4 - 6 MANOR ROAD
TEDDINGTON

FLOOD RISK ASSESSMENT ADDENDUM

ISSUE: FINAL

ISSUE DATE: NOVEMBER 2016

Drawing 1 – Revised Development Section

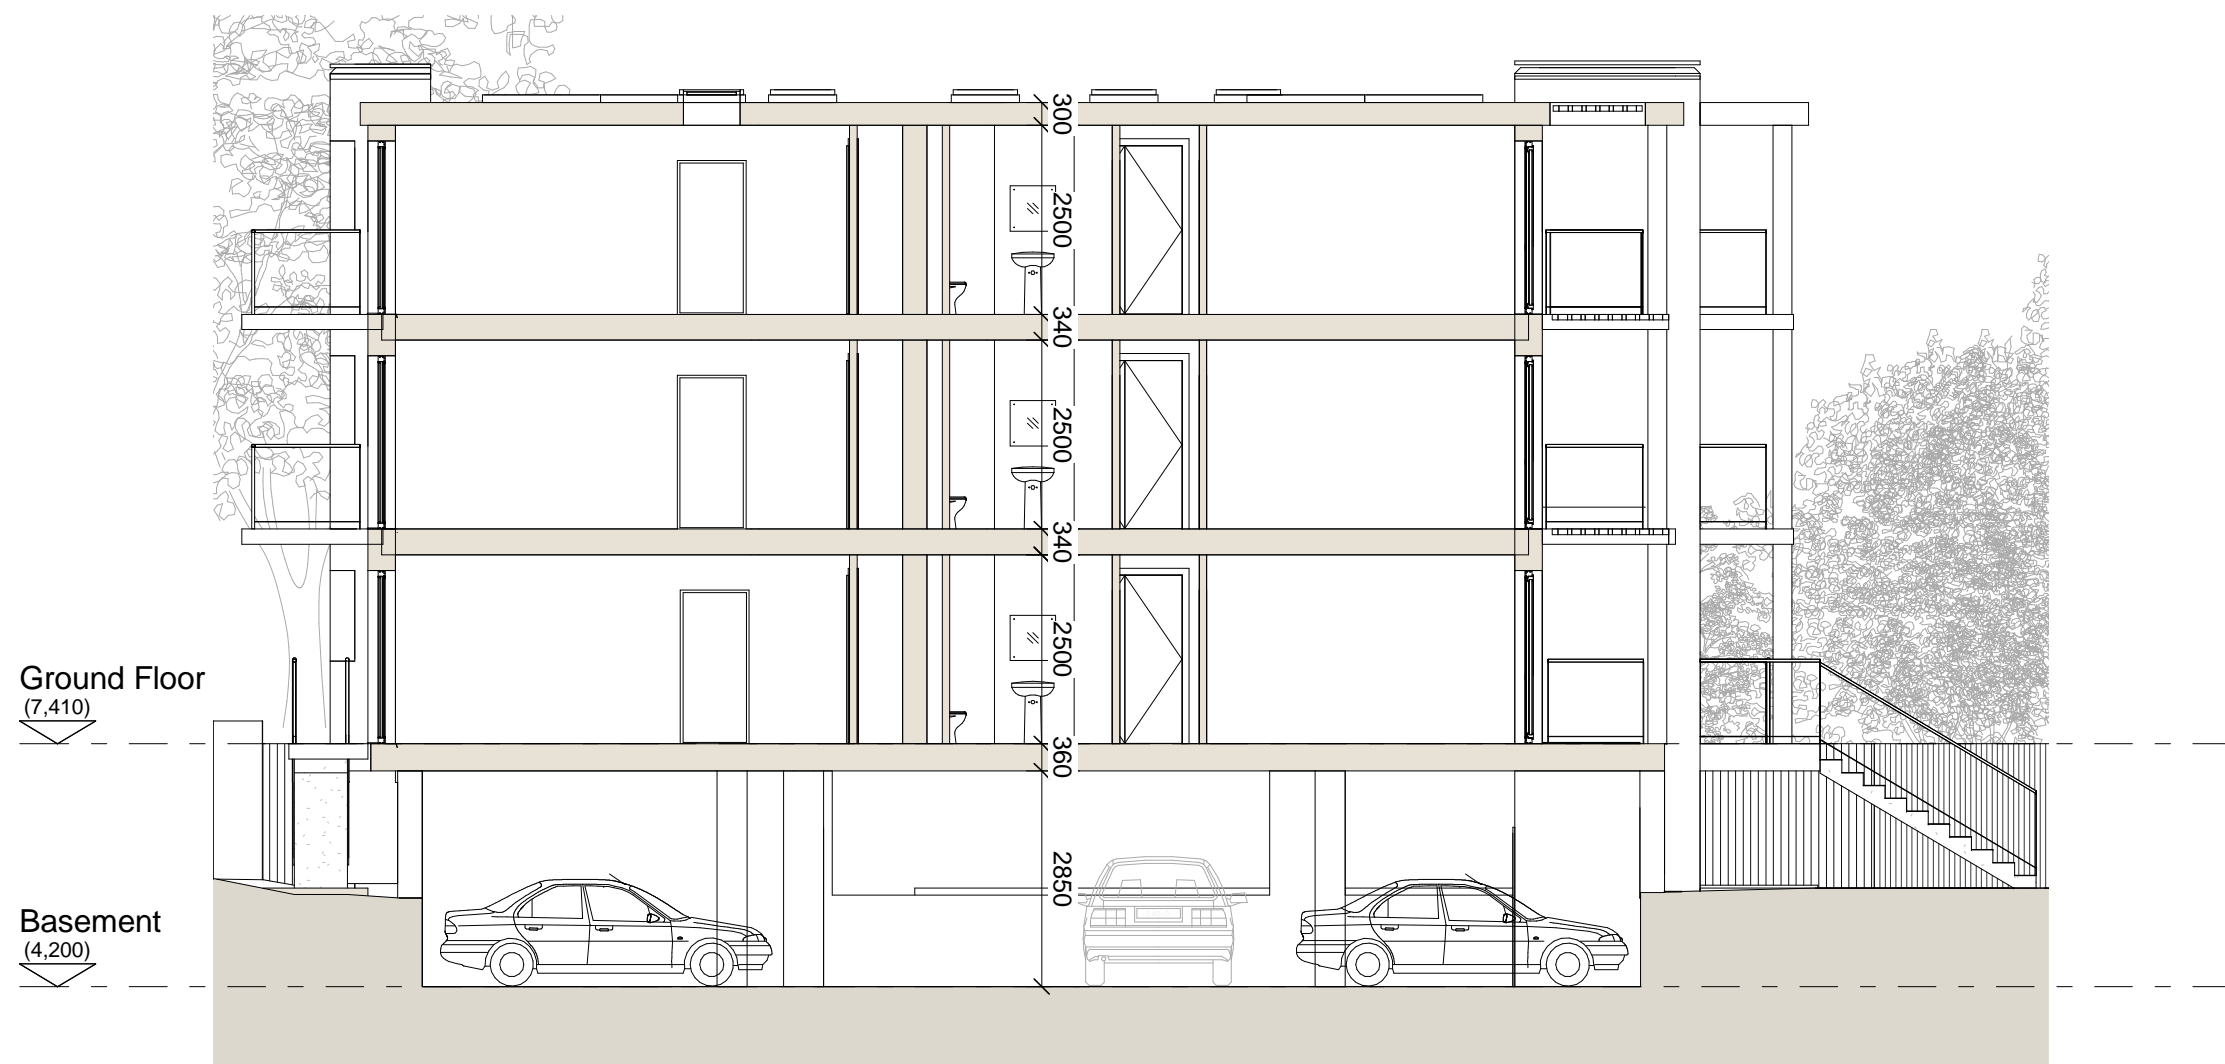
Section through proposed development, showing finished floor levels and reduced slab depth, increasing the soffit level to 7.05m AOD.

Rev	Description	Issued	Dwn	Chk
A	Soffit of Ground Floor raised at Number 6.	04.11.16	IF	AW

- 4.2 Following analysis contained within this FRA addendum, discussions have been undertaken with the structural engineers who have confirmed that it is feasible to reduce the required depth of the slab beneath the finished floor level. As such, it has been possible to raise the slab soffit level to 7.05m AOD, the Higher Central flood water level.
